Comments related to some ERR slides

Rolf Ent and Bogdan W

June 6, 2019 meeting

R4125 gain and anode current

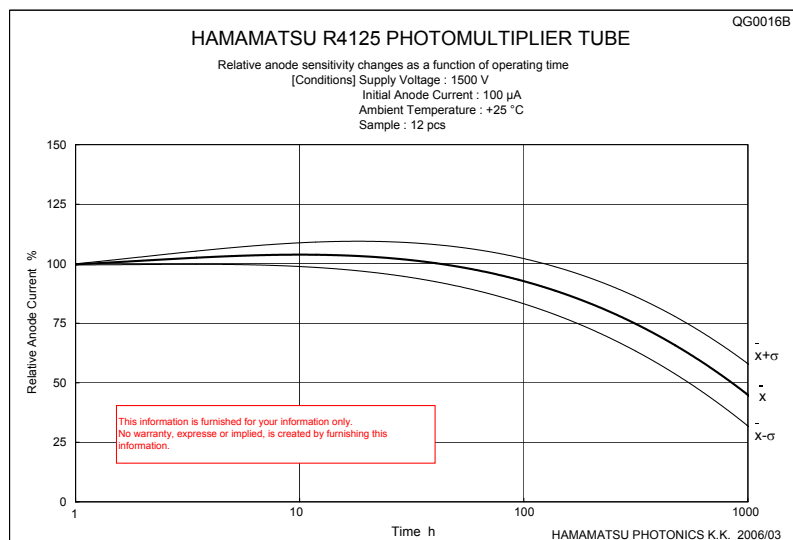
Energy flow 1 rad/s ?? use 0.1 rad/s /per **1 uA**

0.1 rad/s $\Rightarrow 10^{-6}$ J/s/g $\Rightarrow 10^{-4}$ J/crystal
 $\Rightarrow 10^{15}$ eV/s $\Rightarrow 10^6$ GeV/s

signal has 15 ph.e./MeV for NPS scintillator

$\Rightarrow 1.5 \cdot 10^{10}$ ph.e./s in PMT gain of 10^5

\Rightarrow average anode current = **250 uA**

It is 2 times exceed the specs of R4125

**New Photomultiplier Active Base for Hall C
Jefferson Lab Lead Tungstate Calorimeter**

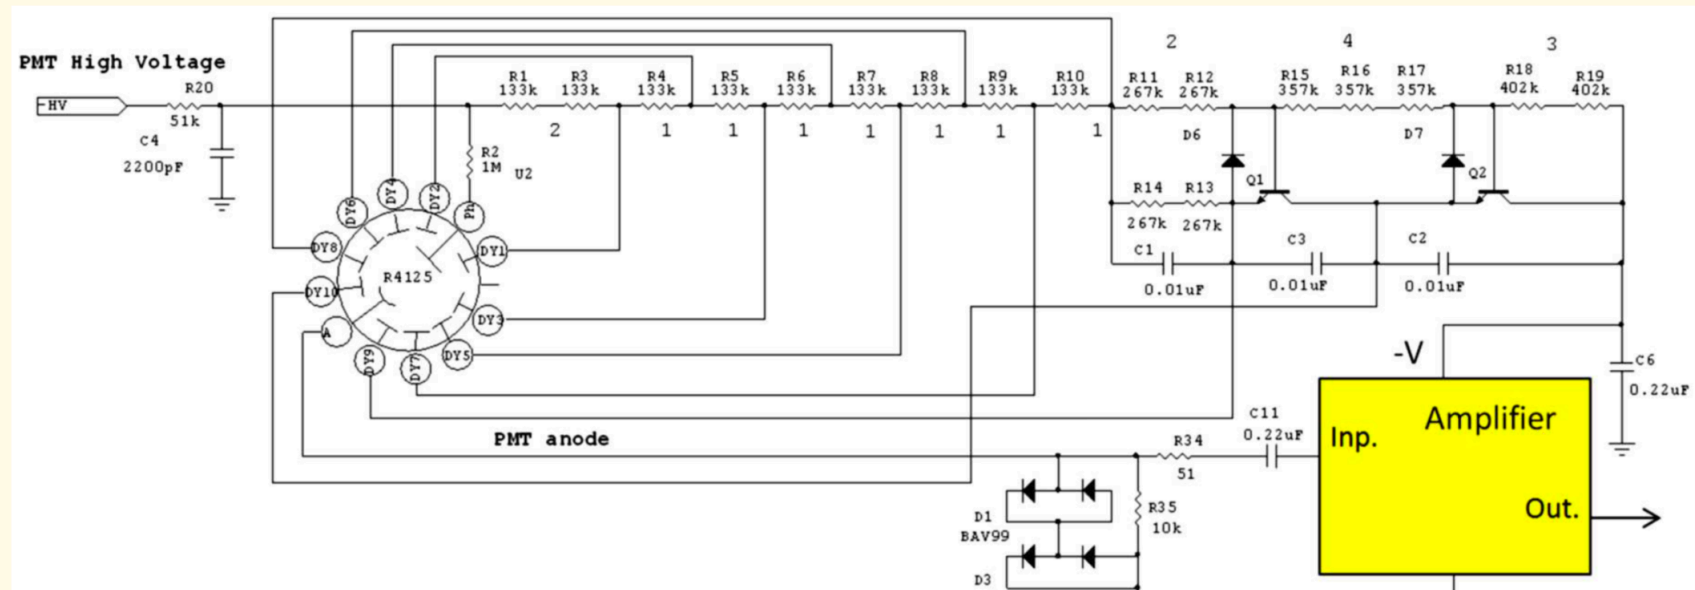
Some differences
with this paper

Conclusions +

- HV divider is not obvious
- Total linearity is a concern
- The anode current is a concern

Linearity of the FADC peak amplitude

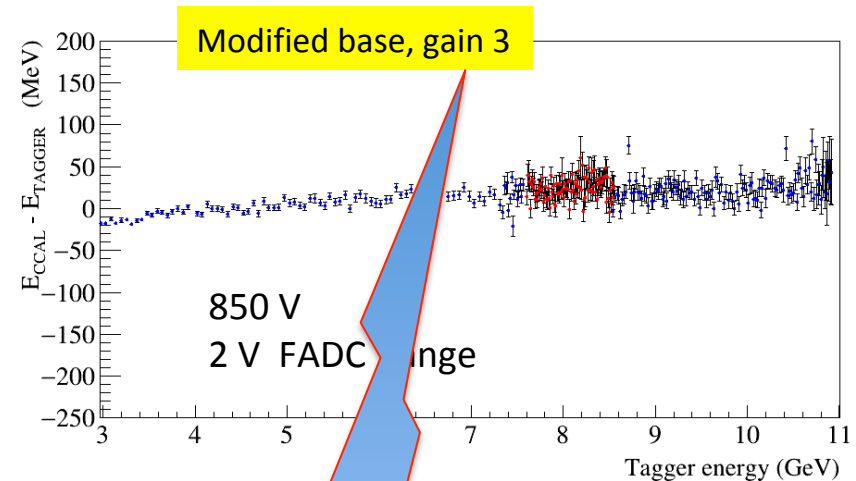
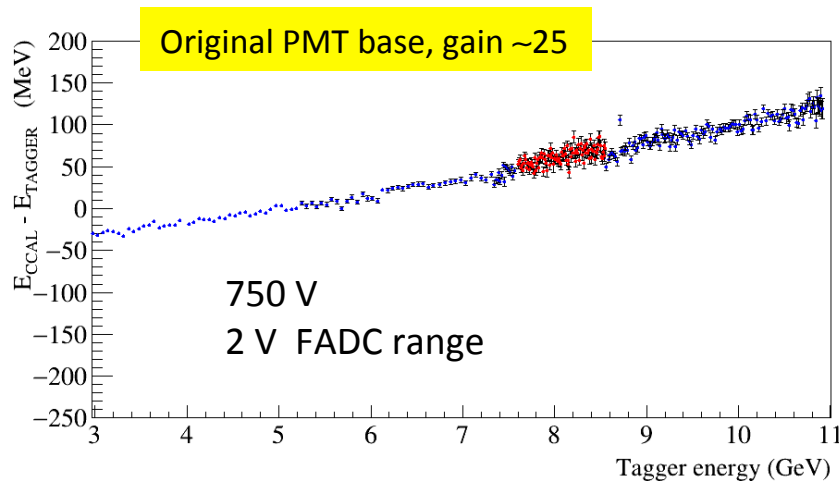
- Some non-linearities on the level of 2 – 3 % in the calorimeter response were observed for the original PMT base for both the peak amplitude and pulse integral
 - PMT was operated at relatively small HV, recommended HV is about 1 kV
- The linearity can be improved by reducing the amplifier gain and increasing HV. Some tuning of the PMT base may be required

Is it a low gain amplifier. Why to use it?
